INDESIT company

Model type:
LV640AROW

Commercial code:
F029945

n1045082: Timer Bit 100 programmes for Evo3 60cm dishwashers

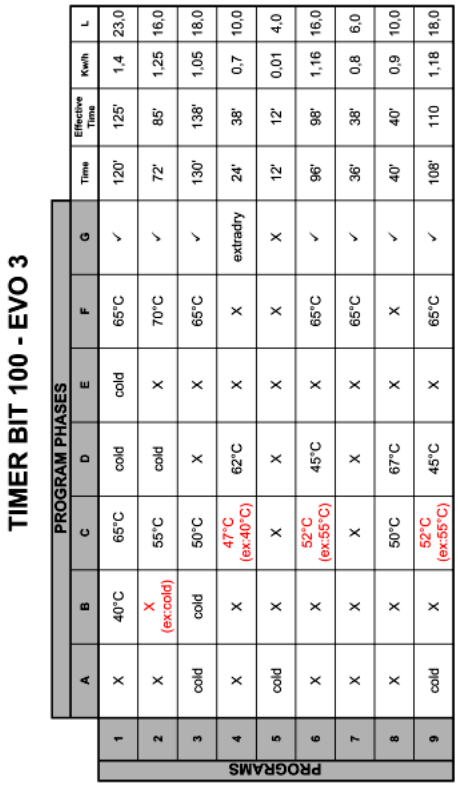
Table N1045082FIG1 shows information relevant to the programmes of the following Timer Bit 100 for Evo 3 60 cm dishwashers:
Timer BIT 100 - E1 - Service code 097890 (rohs 143206);
Timer BIT 100 - E2 - Service code 097481 (rohs 143207);
Timer BIT 100 - E3 - Service code 099892 (rohs 143208);
Timer BIT 100 - S1 - Service code 109875 (rohs 143211).

PROGRAMME MODIFICATIONS ARE INDICATED IN RED.

PROGRAMS	PROGRAM PHASES											
	A	B	C	D	E	F	G	Time	Effective Time	Kwh	L
1	X	40°C	65°C	cold	cold	65°C	✓	120'	125'	1,4	23,0
2	X	X (ex:cold)	55°C	cold	X	70°C	✓	72'	85'	1,25	16,0
3	cold	cold	50°C	X	X	65°C	✓	130'	138'	1,05	18,0
4	X	X	47°C (ex:40°C)	62°C	X	X	extradry	24'	38'	0,7	10,0
5	cold	X	X	X	X	X	X	12'	12'	0,01	4,0
6	X	X	52°C (ex:55°C)	45°C	X	65°C	✓	96'	98'	1,16	16,0
7	X	X	X	X	X	65°C	✓	36'	38'	0,8	6,0
8	X	X	50°C	67°C	X	X	✓	40'	40'	0,9	10,0
9	cold	X	52°C (ex:55°C)	45°C	X	65°C	✓	108'	110	1,18	18,0

n1045083: Modification of filters on EVO3 60 cm dishwashers

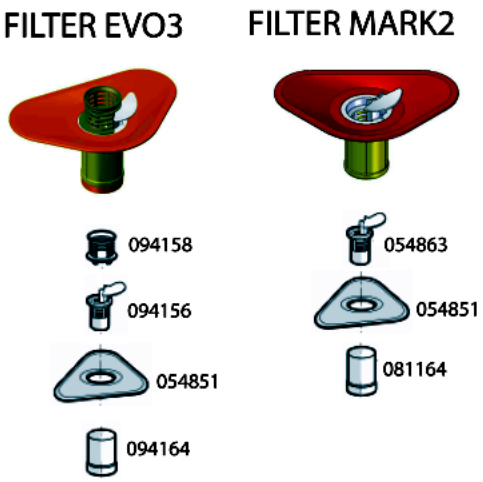
All dishwasher models affected by this modification have been equipped with the items listed below, in order to solve the drain pump clooging problem.

Introduction of:
Cylindrical plastic filter code 081164
Central filter code 054863

Elimination of:
Cylindrical plastic filter code 094164
Central filter code 094156
Central filter grid code 094158

The modification has been introduced progressively, starting from serial no. 40516.0001.

n1045085: Introduction of new litre counter turbine integrated on air-break.

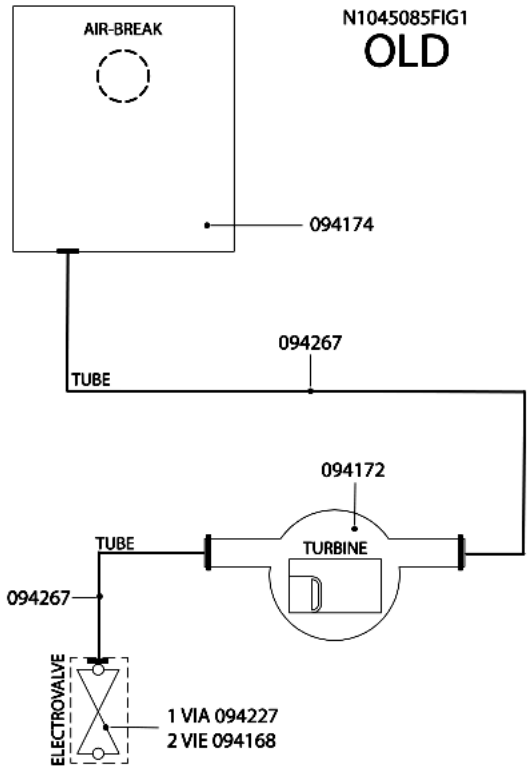
All dishwashers affected by this note have been equipped with a new litre counter turbine on the air-break.
Picture N1045085FIG1 illustrates the premodification structure, picture N1045085FIG2 the new structure.

Items affected by the modification.

AIR-BREAK:
new 110610;
premodification 094174;
the new item features a new integrated litre counter turbine and its water supply hose has a smaller diameter.

LITRE COUNTER TURBINE code 094172 has been eliminated.

SOLENOID VALVES:
new:
1-WAY code 110611;
2-WAY code 084558(Rohs 143737);
premodification:
1-WAY code 094227;
2-WAY code 094168;
the new solenoid valves have a smaller diameter drain hose fitting.

HOSES:
new solenoid valve hose/air-break code 110612;
premodification turbine hose/air-break code 094267;
premodification solenoid valve hose/air-break code 094267;
the new hose has a smaller internal diameter.

WIRING:
the litre counter turbine connecting cable is longer, but since the connector is the same, the new item can be used in place of the premodification one.

n1045093: Modification of light blue folding shelf attachment.

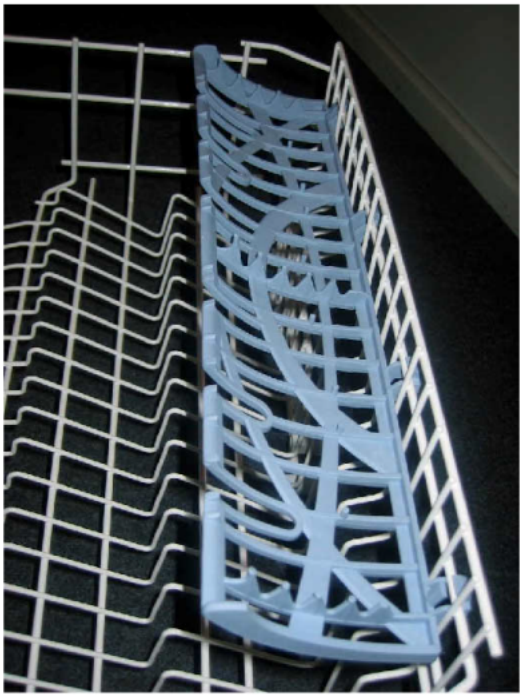
From serial no. 41109.0001 all models affected by this bulletin feature a modification of the folding shelf to upper basket coupling system.
This modification called for alteration of the relative baskets: the distance between the wire on which the folding shelf is attached and the wire below it has been increased from 9.5 mm to 17 mm, as shown in the attached image.
The altered folding shelves are not interchangeable and cannot be installed on premodification baskets: in the case of service interventions on product with serial number prior to 41109.0001 the entire upper basket must be replaced.
The baskets are reciprocally interchangeable and are managed as assemblies complete with their accessories, inclusive of folding shelves.

UPPER BASKET LIGHT BLUE FOLDING SHELF
new 114799 - premodification 094140.

UPPER BASKET ASSEMBLIES
new 115001 - premodification 094139;
new 115002 - premodification 094222;
new 115003 - premodification 094233.

N1045093FIG1
NEW FLAP UPPER BASKET SAT CODE 114799

N1045093FIG2
OLD FLAP UPPER BASKET SAT CODE 094140
